Subject: Holtec International HI-STORM Flood/Wind Multipurpose Canister Storage System, USNRC Docket No. 72-1032, License Amendment Request 1032-1

Reference: Holtec Project 5018
LAR 1032-1

LAR 1032-1, REVISION 0

SUMMARY OF PROPOSED CHANGES

Figure 2.1-1
MPC-37 Region-Cell Identification

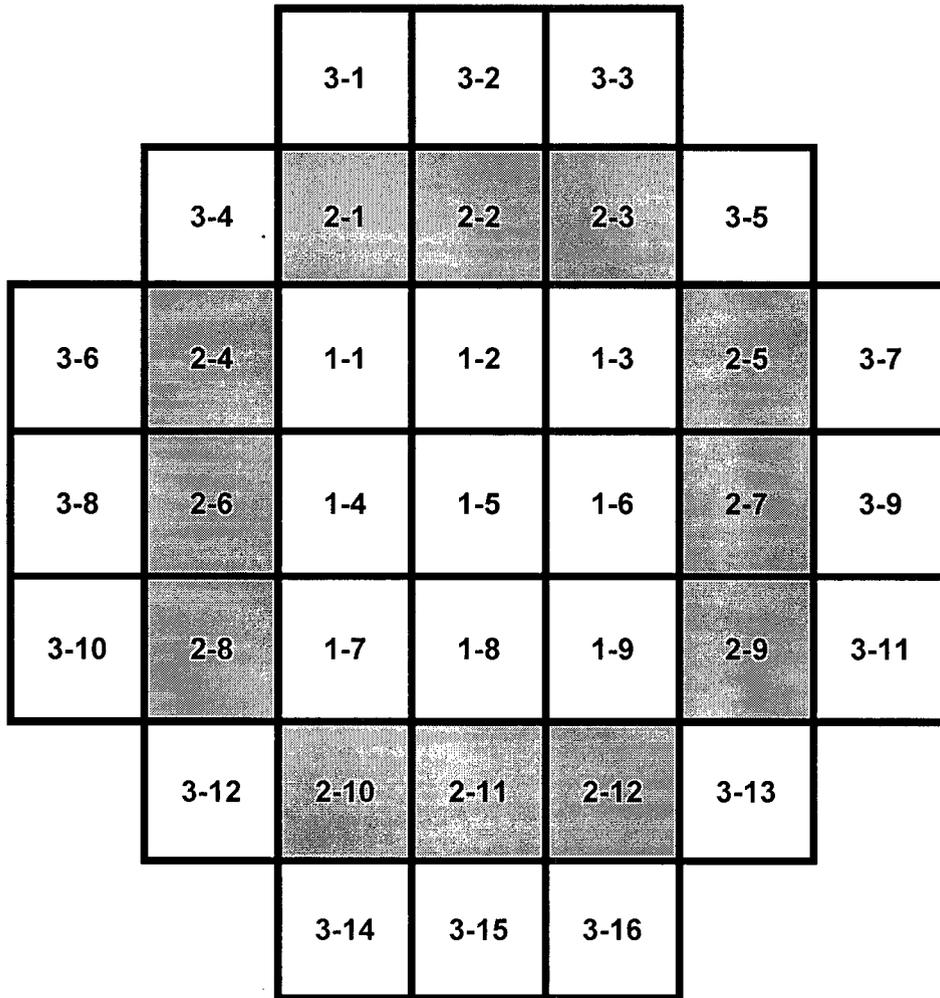
Appendix B, Section 2.3; MPC-37 "Pattern B" decay heat limits for the cells/regions/total MPC are added to Table 2.3-1.

TABLE 2.3-1 MPC-37 HEAT LOAD DATA (See Figure 2.1-1)					
Number of Regions:		3			
Number of Storage Cells:		37			
Maximum Heat Load (kW):		47.05 (Pattern A); 46.8 (Pattern B)			
Region No.	Decay Heat Limit per Cell, kW		Number of Cells per Region	Decay Heat Limit per Region, kW	
	Pattern A	Pattern B		Pattern A	Pattern B
1	1.13	1.2	9	10.17	10.8
2	1.78	1.2	12	21.36	14.4
3	0.97	1.35	16	15.52	21.6

Figure 1.2.1: MPC-37 Basket, Region and Cell Identification

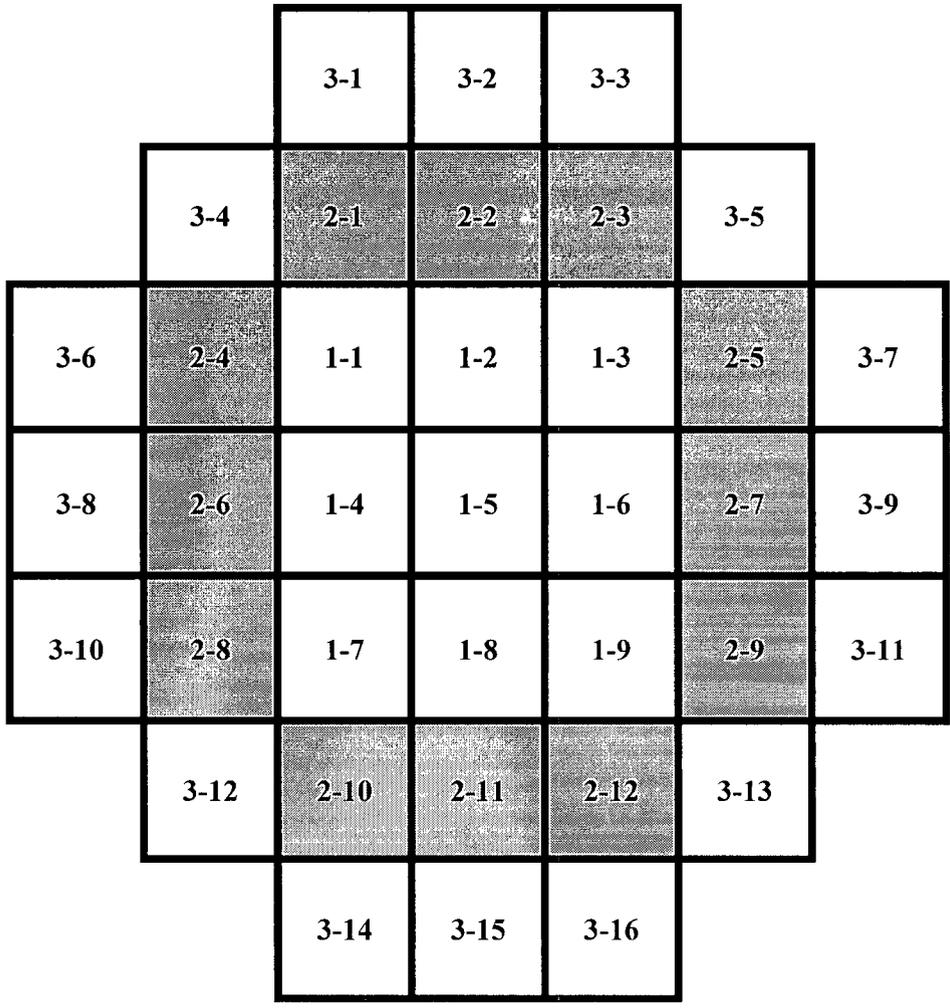
TABLE 1.2.3(b) Pattern B MPC-37 HEAT LOAD DATA (See Figure 1.2.1)			
Number of Regions:		3	
Number of Storage Cells:		37	
Maximum Heat Load:		46.8 kW	
Region No.	Decay Heat Limit per Cell, kW	Number of Cells per Region	Decay Heat Limit per Region, kW
1	1.2	9	10.8
2	1.2	12	14.4
3	1.35	16	21.6
